**JOINT REGIONAL PLANNING PANEL  
(Sydney East Region)**

<b>JRPP No</b>	<b>2011SYE120</b>
<b>DA Number</b>	<b>2011/575</b>
<b>Local Government Area</b>	<b>Willoughby</b>
<b>Proposed Development</b>	<b>Demolition of existing buildings and construction of a 12 storey building for purposes of a Boarding House, business identification signs, and associated works.</b>
<b>Street Address</b>	<b>73 &amp; 77 Albert Ave Chatswood</b>
<b>Applicant</b>	<b>Iglu Pty Limited</b>
<b>Number of Submissions</b>	<b>6</b>
<b>Recommendation</b>	<b>Approval with Deferred commencement Conditions</b>
<b>Report by</b>	<b>Annie Leung - Development Planner</b>

## Assessment Report and Recommendation

### 73 & 77 ALBERT AVE CHATSWOOD

**Figure 3 - Extract from submitted SEPP 1 objection against height standard illustrating skyline/building heights of Chatswood CBD in comparison to the proposed development.**

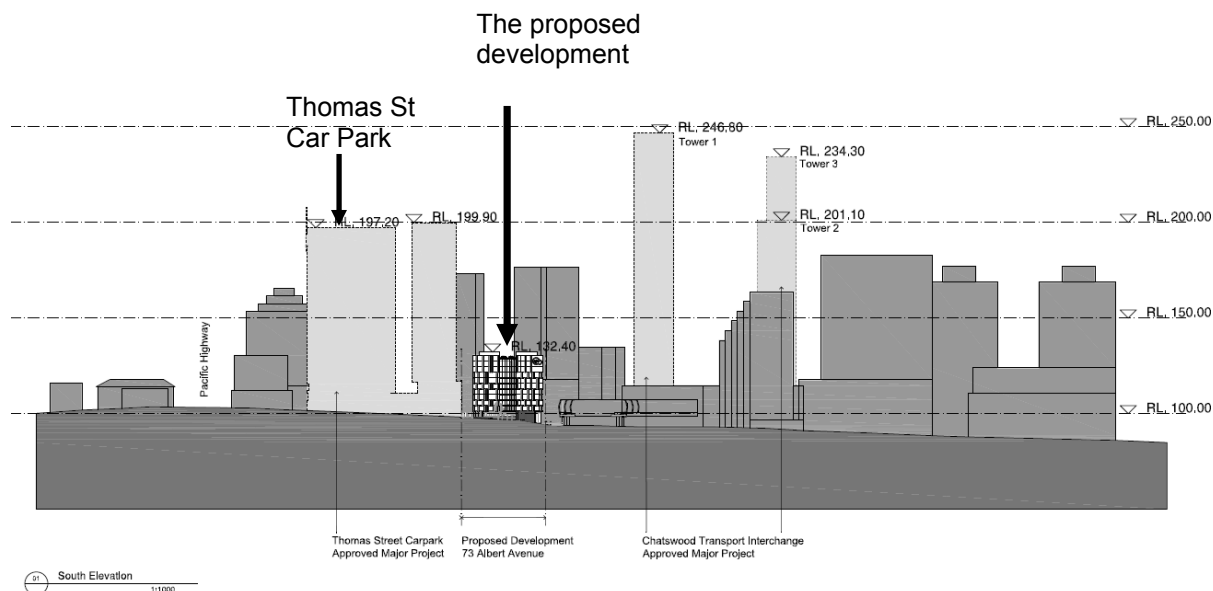
Comments: Similar to the consideration of the application's SEPP 1 objection against the FSR standard in SREP 5 as previously discussed in this report, the current Height standard contained in SREP 5 presents significant discrepancies with the actual development context of the site due to approved building heights of recent development in the vicinity of the site being well above the current standard. The submitted SEPP 1 objection includes the following diagram which clearly illustrates a development context of much greater building heights than those permissible under SREP No 5.

The proposed height standard contained in exhibited Draft WLEP 2012 (and previous Draft WLEP 2009) is considered to better reflect building heights of recent developments in Chatswood CBD and the desired future character of the precinct. The draft height standard in Draft WLEP 2012 is a maximum of 34m. The proposed development is largely consistent with the draft height control, with the exception of its eastern elevation facing the railway line, and parts of its lift overruns. The proposed building along its eastern elevation is up to 36m in height (2m above the draft standard). The lift overrun for the eastern wing of the proposed building is up to 37.5m in height. The lift overrun for the western wing is below 34m.

**Figure 4 - Extract from submitted additional shadow diagrams received showing overshadow impacts of the proposed development, and overshadowing impacts of the proposed development should strict compliance to building height of 34m is achieved.**

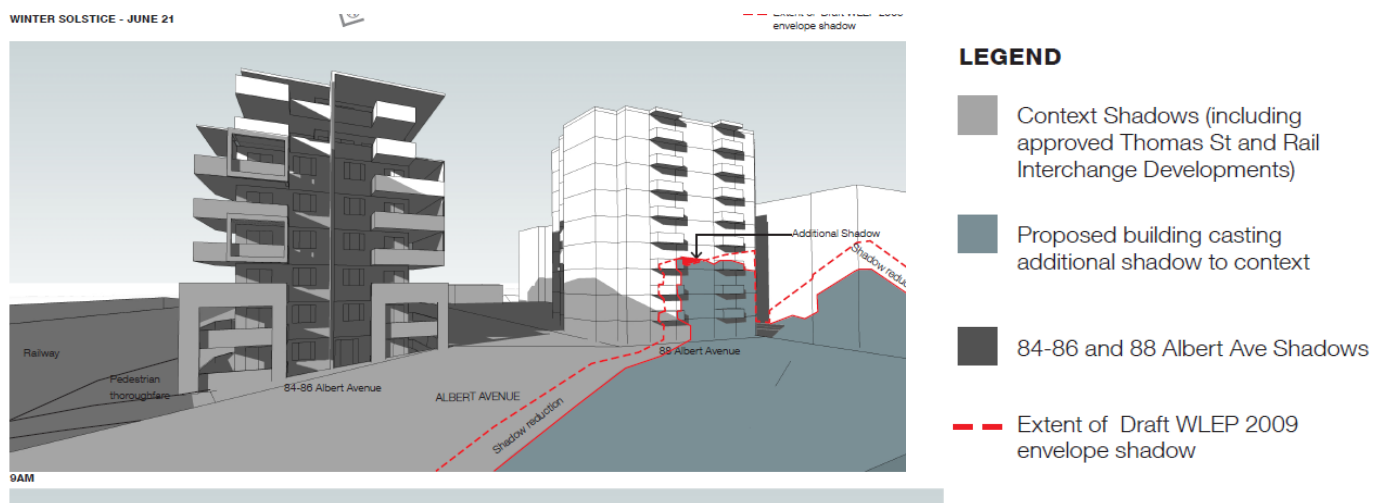
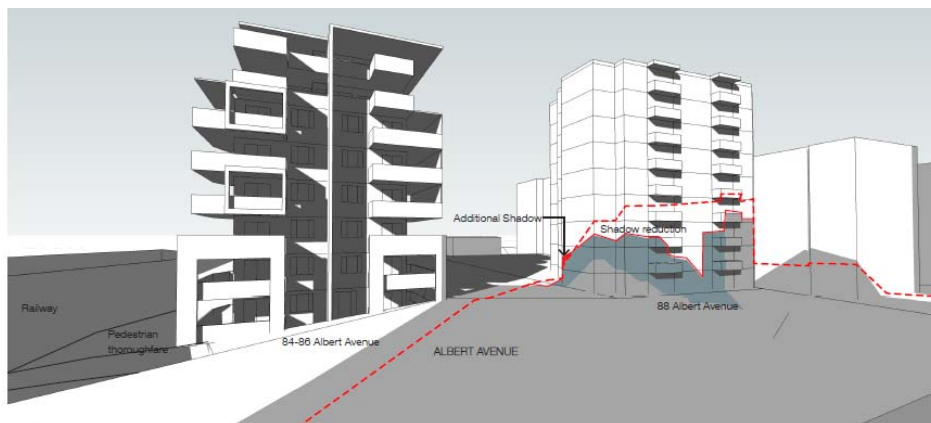
Those parts of the proposed building encroaching on the draft height standard do not significantly contribute to the external impacts of the proposed development, including overshadowing. Additional shadow diagrams have been requested from the applicant in comparing the proposed development if fully in compliant with the draft height control of 34m is achieved against impacts of the proposed development as proposed. The additional shadow diagrams indicate that those parts of the proposed building encroaching above the draft height standard of 34m has no material effects to solar access to the residential units on the southern side of Albert Ave. (See diagrams below)

Building Height and Overshadowing: *“The height controls in the LEP also indicate increase of height immediately to the north of the site which will also add to the overshadowing issue by the potential future developments. GMU understands that the site is on the edge of Chatswood Town Core. The proposed height is close to the LEP height and the area is constrained due to its location on the edge of town centre. Additionally the new approved developments already affect the residential areas, as shown on the shadow diagrams provided in the original DA set.*

*GMU suggestion is to test if lowering the height would allow more solar access to the site across the street. The minimum would be to lower the built form to at least meet the LEP height on the eastern corner. The change in height might not resolve the overshadowing issue completely, but might reduce the number of affected apartments.”*

- The contextual shadows from existing buildings, approved buildings, and structures to the residential flat developments on the southern side of Albert Ave already significantly affect solar access to these units. Future developments on the northern side of Thomas Street and Albert Ave based on the height and density proposed in the Draft WLEP 2012 will further add to these overshadowing impacts.

**Figure 5 - Extract from submitted drawing A11.001 [A]**

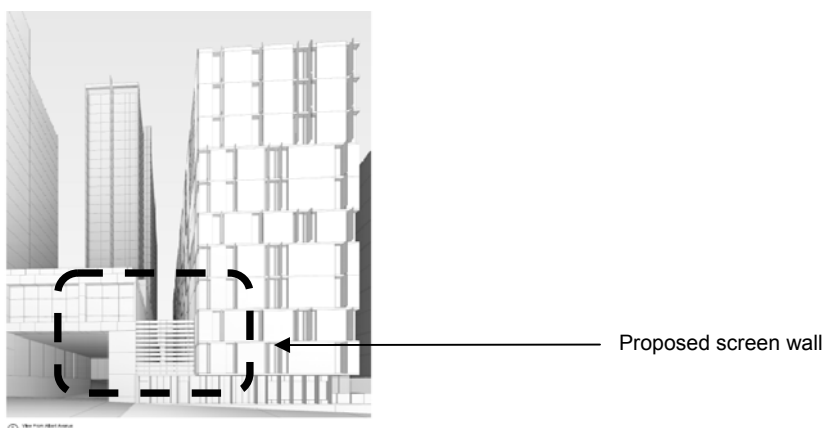
Thomas Street Car Park (western boundary): *“To the west, the proposal has a setback of approx. 6m to the boundary for all levels except level 1.” ..... “It is questionable if 6m setback will be enough to provide adequate amount of solar access to the rooms on levels 2-5. The outlook to the blank wall has been softened by landscape proposed on the roof of Level 1 between the buildings as detailed on revision drawings from 4th of April, number A03.002(C) received from Bates Smart and drawing DA-L-8 from Turf landscape design. The proposed landscaped planter along the western boundary of the site significantly improves the amenity and outlook for the rooms looking onto the eastern wall of the future development to the west.”*

- The 6 storey podium height as recommended by Council's Urban Design consultant relied upon the adjoining approved development for the existing Thomas Street car park. However, further review of the plans of the approved Thomas Street car park development shows that varied front setbacks and different podium heights have been approved for the two main tower buildings facing Albert Ave. In this regard, any extension of a podium form to the proposed development will not result in continuation in setback or podium height along Albert Ave.

- The creation of a 6 storey podium to the proposed development will add to the depth of the proposed rooms and units on level 2 and level 3, and significantly limit access to light and ventilation for these rooms. Due to the usage of the proposed development being a form of residential accommodation, there are significant constraints/consequences in providing a substantial podium in a similar manner as the adjoining approved development, which will accommodate commercial floorspace and vehicular access in the podium form.

- The proposed screen on the Albert Ave frontage of the development, between the proposed development and adjoining Thomas Street Car Park development be deleted as it does not positively contribute to the streetscape or the appearance of the proposed building. (**Condition 7**)
- A detailed landscaped plan be developed for the setback area between the proposed development and its western boundary (adjoining Thomas Street car park). The landscape plans should include planting of suitable tree species above the proposed podium to soften the visual transition between the proposed development and adjoining development as viewed from Albert Ave and further improve amenity of west facing boarding rooms with outlook to this area. (**Condition 6**)

**A08.005(B)**  
Batesmart Pty Ltd  
73 Albert Ave  
Sydney NSW 1580  
Tel: 02 9550 1111  
Fax: 02 9550 1112  
Email: info@batesmart.com.au  
Website: www.batesmart.com.au

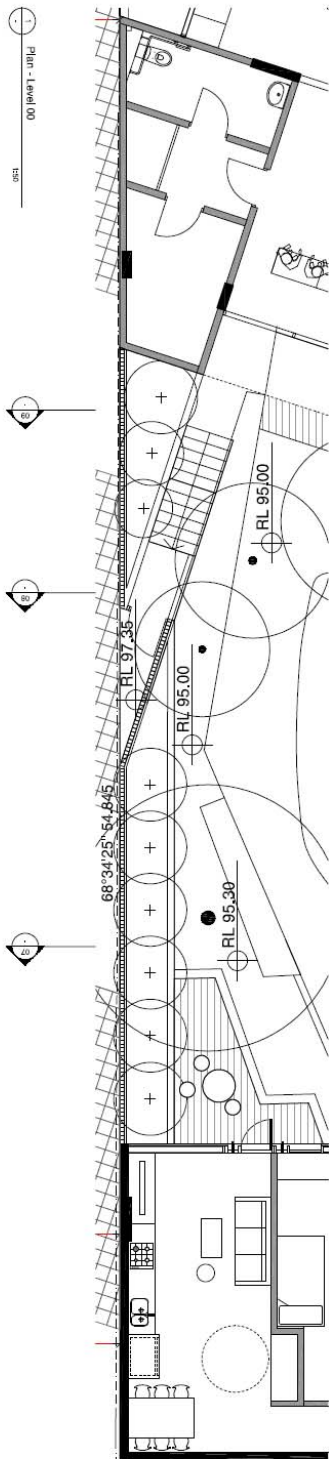
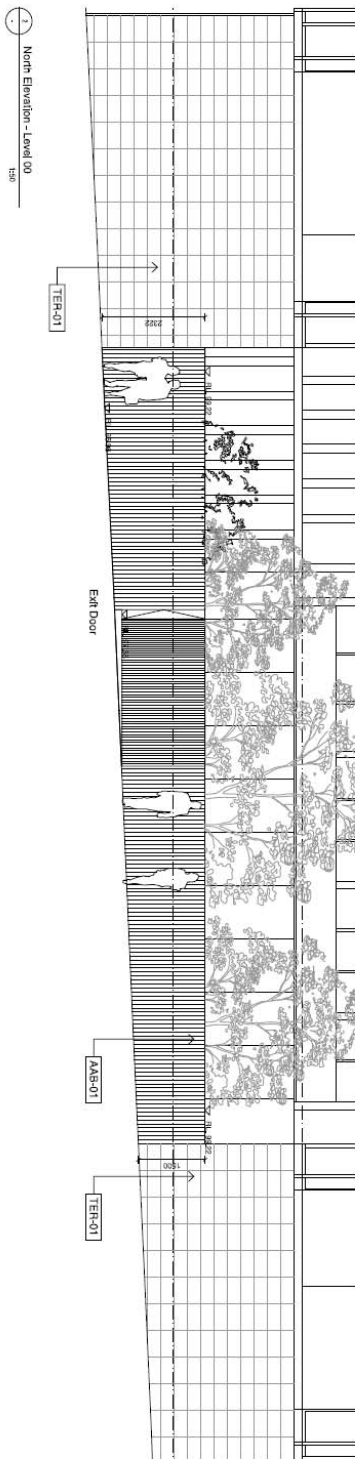
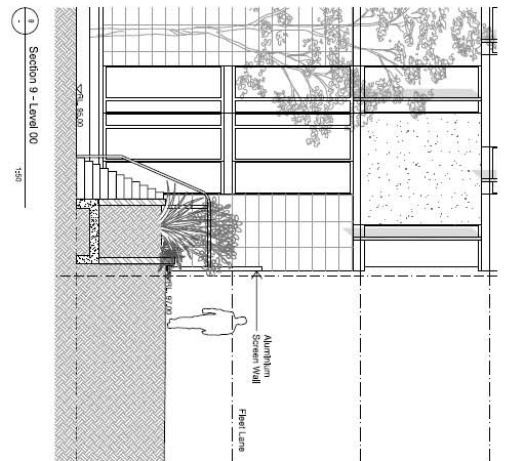
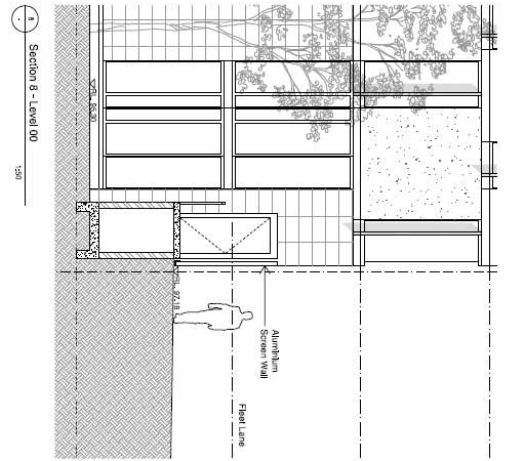
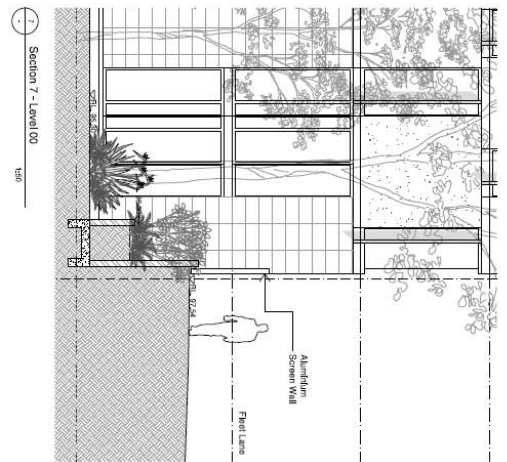
Fences and Walls: *"The aluminium batten fence added to the boundary between the lane and the internal courtyard addresses the issue of the lack of adequate height to the northern boundary fence."*

Comments: See amended drawing numbered A08.005[B].
